Western Ring Route-Waterview Connection

Review of the Air Quality Assessment and
evidence with relevance to air quality

Preliminary Report prepared for
the Board of Inquiry

22 December 2010

Figure 3: Approach taken to incorporate existing air quality (NZTA, 2010a)

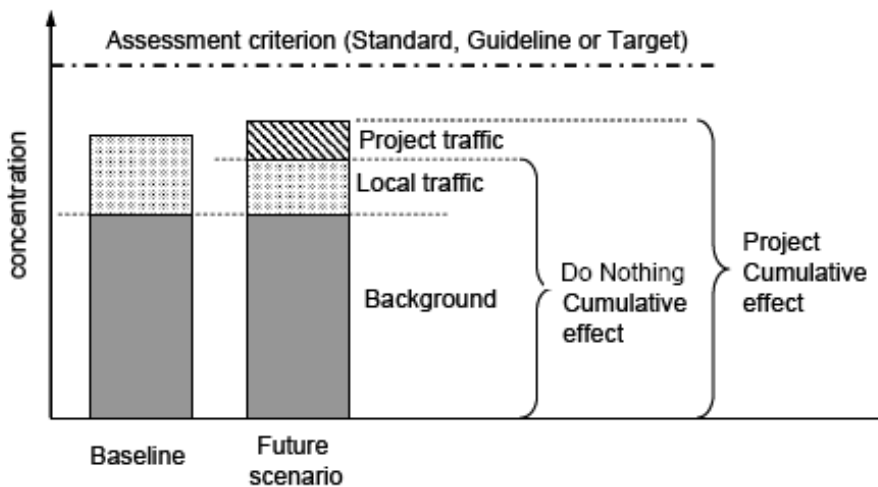
70. The results of NZTA monitoring demonstrate that the concentration of PM_{2.5} in the Oakley Creek valley is elevated, primarily due to localised domestic fire emissions. To reflect the results of monitoring that has been undertaken subsequent to the preparation of the assessment, it should be recognised that background concentrations of PM₁₀ and PM_{2.5} are higher than assumed in the Assessment.

71. The assessment is based on an assumed baseline concentration of PM₁₀ in the Oakley Creek valley of 38µg/m³. The highest measured concentration at Alan Wood Reserve was 43.8µg/m³ in 2009. This means that the cumulative concentration of PM₁₀ could realistically be 5.8µg/m³ (over 10% of the standard) higher than predicted in Sector 9.

72. The assessment is based on an assumed baseline concentration of PM_{2.5} in the Oakley Creek valley of 24µg/m³. The highest measured concentration at Alan Wood reserve was 36.5 µg m³ in 2009. This means that the cumulative concentration of PM_{2.5} could realistically be 12.5µg/m³ higher (50% of the regional target) than predicted in Sector 9.
